Amendments to the Drawings:

The formal drawing Replacement Sheet attached in connection with the above-identified application containing Figure 2 is being presented as new formal drawing sheet to be substituted for the previously submitted drawing sheet. The drawing figure 2 has been amended. The specific changes which have been made are listed below:

FIGURE 2

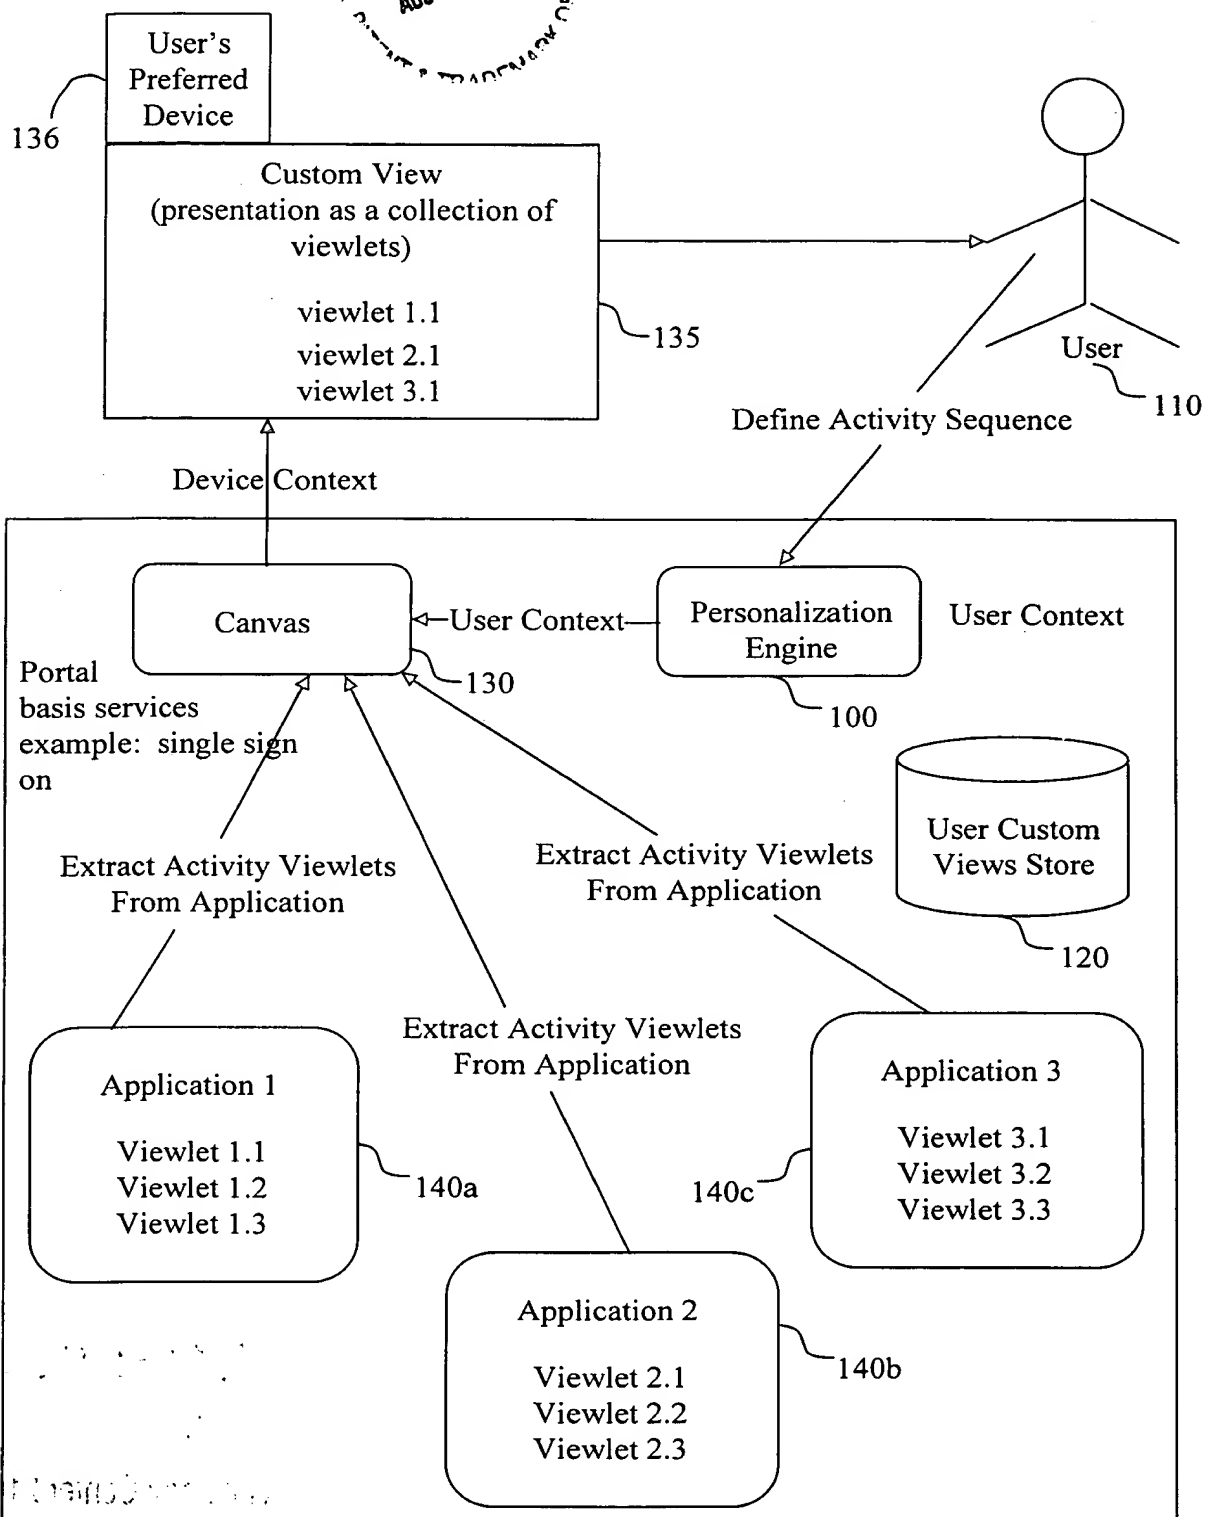
Element 140a label "Viewlet 4.1" is changed to --Viewlet 1.1--.
